UNITED STATES PATENT AND TRADEMARK OFFICE

Office Action Summary

10/587,176

DETAILED ACTION

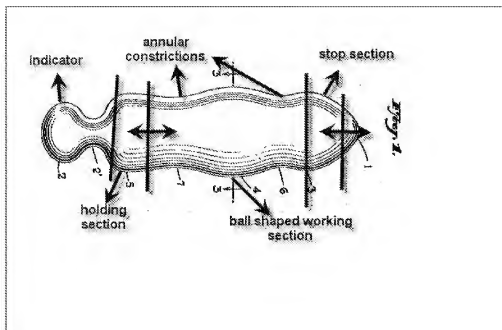
Claim 10 - the device of Waters is compressible, column 2 lines 18-22. See the elements labeled below.

Claim 11 - the working section is "essentially" spherical.

Claims 12 and 13 - the lengths of the stop section and the holding section may be selected to fall within the claimed ranges. The sections may be selected by drawing lines perpendicular to the longitudinal axis of the device and moving them longitudinally to select the desired dimensions. The claims do not set forth specific structure to define the stop section or the holding section so the sections may be selected of any size and therefore meet the claimed ranges.

Claim 14 - element -2- is considered a short rod that is withdrawable from structure the device would be inserted into, such as the vagina.
